Option Three

TRUMAN ELEMENTARY REPLACEMENT SCHOOL

DIMENSIONING PLAN

C2.2

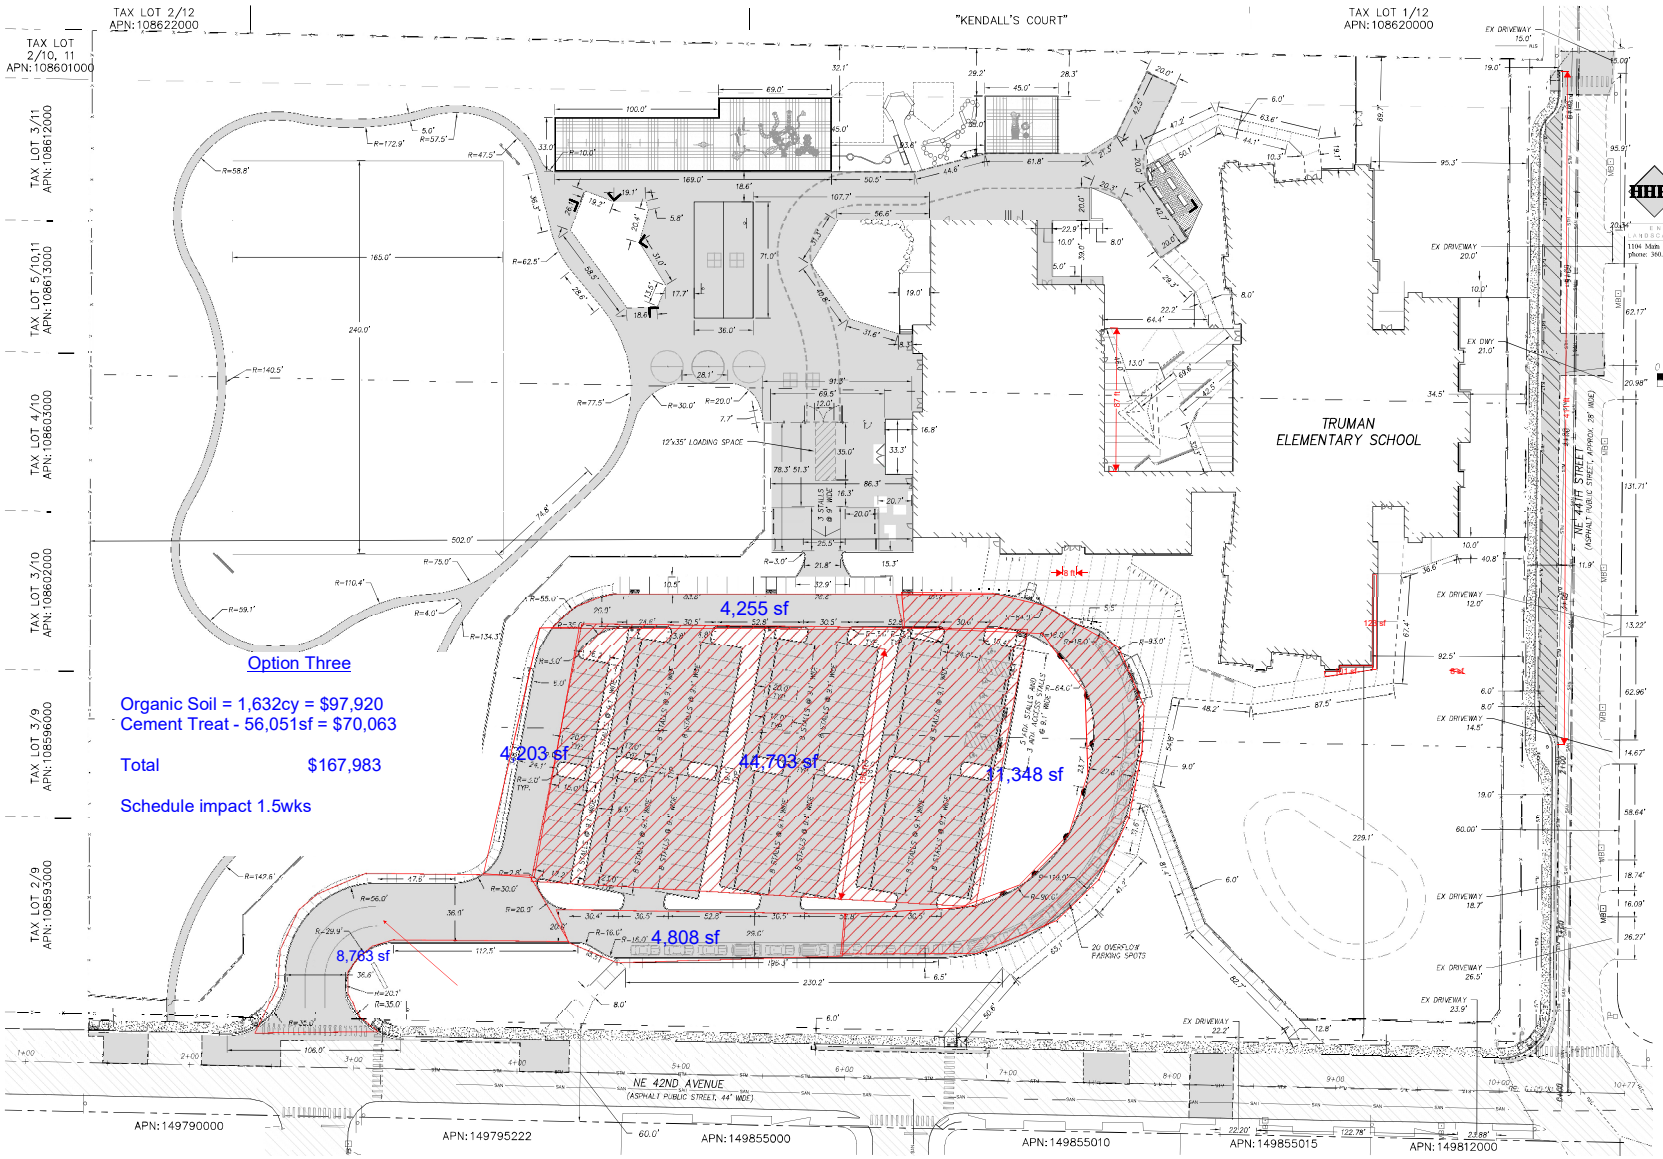
Organic Soil = 1,632cy = $97,920
Cement Treat - 56,051sf = $70,063

Total $167,983

Schedule impact 1.5wks
